# Access Compliance Report

## Public Rights-of-Way

### (Pedestrian Signals)

Intersection ID: N/A	Main Street:	Cross Street: N/A	Location: N/A
ADA ID: 2E6227EA8527	Signal Type: One Push Button-Non APS	Overall Compliance: No	Severity Score: BTN 1: N/A BTN 2: N/A No BTN: N/A
Codes/Mitigation Info/Possible Solution		Field Measurements/Component Compliance

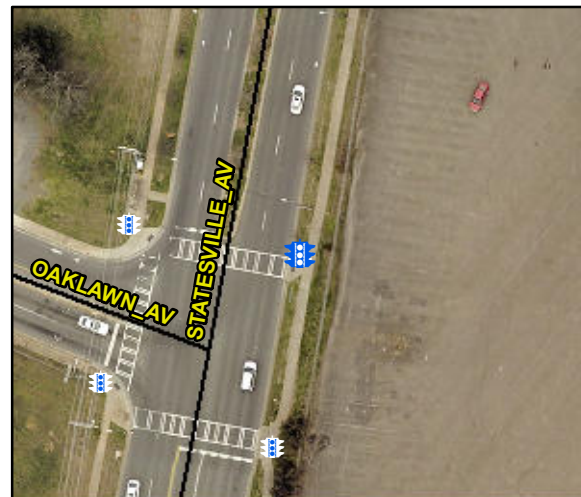
Surveyor Notes: TX HT 5/16

PROW/ADA: R410.6, TMUTCD 4e.08, R406.2, R404.7.3

Possible Solutions: Replace Signal Push Button With APS Button on New Post. Remove & Replace Sign.
